**Panel Report**

**Greater Geelong Planning Scheme Amendment C251 and  
Planning Permit Application 408/2016**

**Former CSIRO site – 1 Henry Street, Belmont**

**24 July 2017**

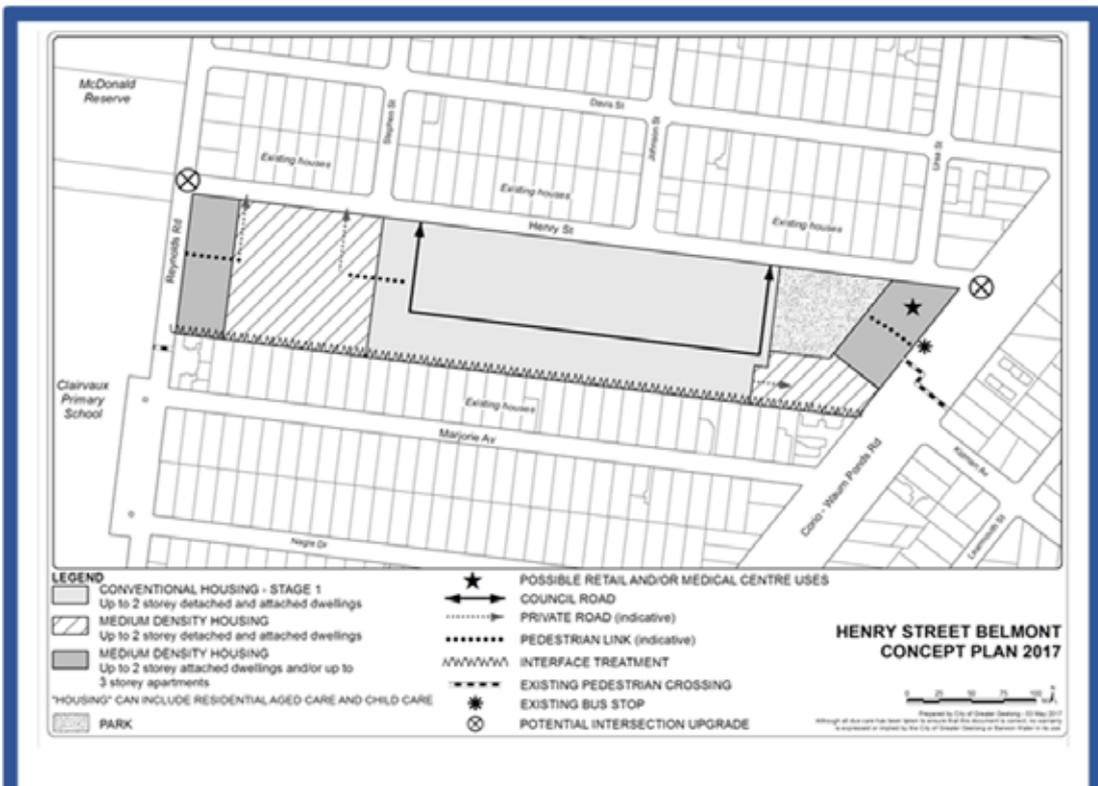
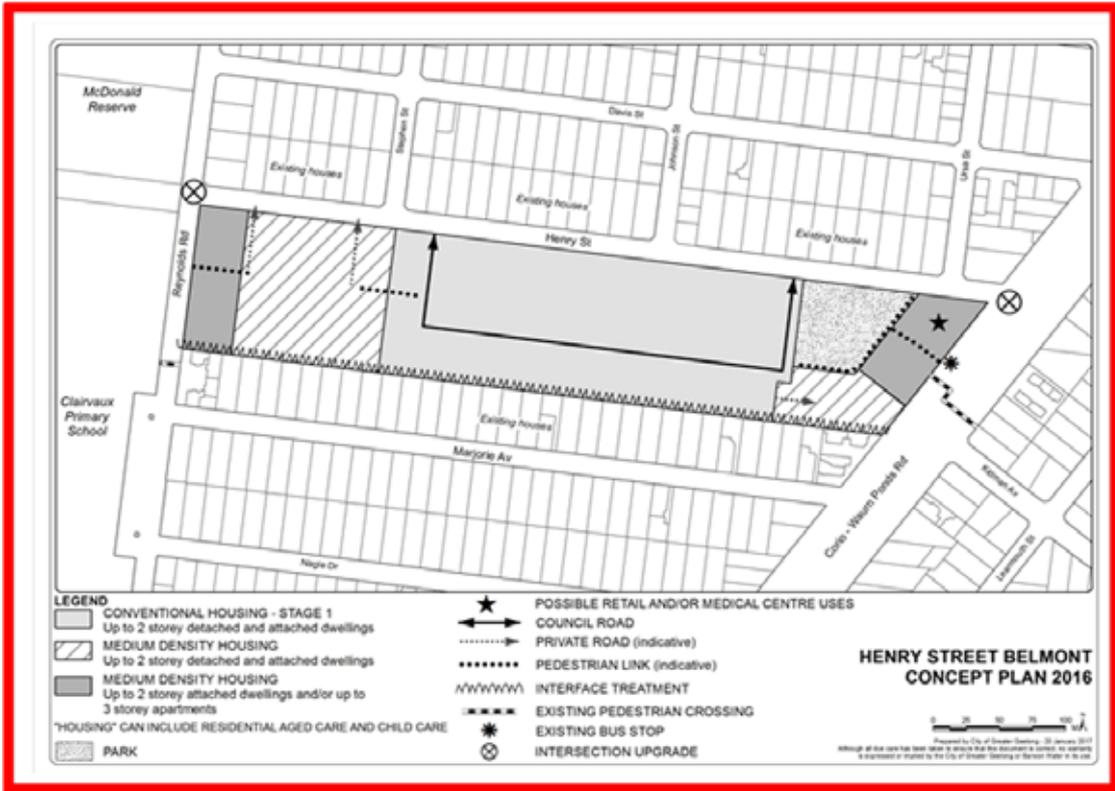
- i) deleting the ‘Pedestrian Link (Indicative)’ from the park as shown on the ‘Henry Street Concept Plan’.
- j) amending Clause 3.0 – Requirements for Development Plan – Urban Design Masterplan, dot point 5 to read *“Identification of the north east corner as a possible site for retail and/or medical centre uses with vehicle access/egress from Corio - Waurm Ponds Road only.”*

**Delete *“Intersection upgrade”* and the associated icon from the ‘Henry Street Belmont Concept Plan’.**

- b) the deletion of *“Intersection upgrade”* and the associated icon from the *‘Henry Street Belmont Concept Plan’*.
  - c) amending Clause 3.0 – ‘Requirements for a Development Plan – Road Network and Traffic Management Plan’ dot Point 6 to read *“No new road access to Reynolds Road and direct residential access minimised.”*
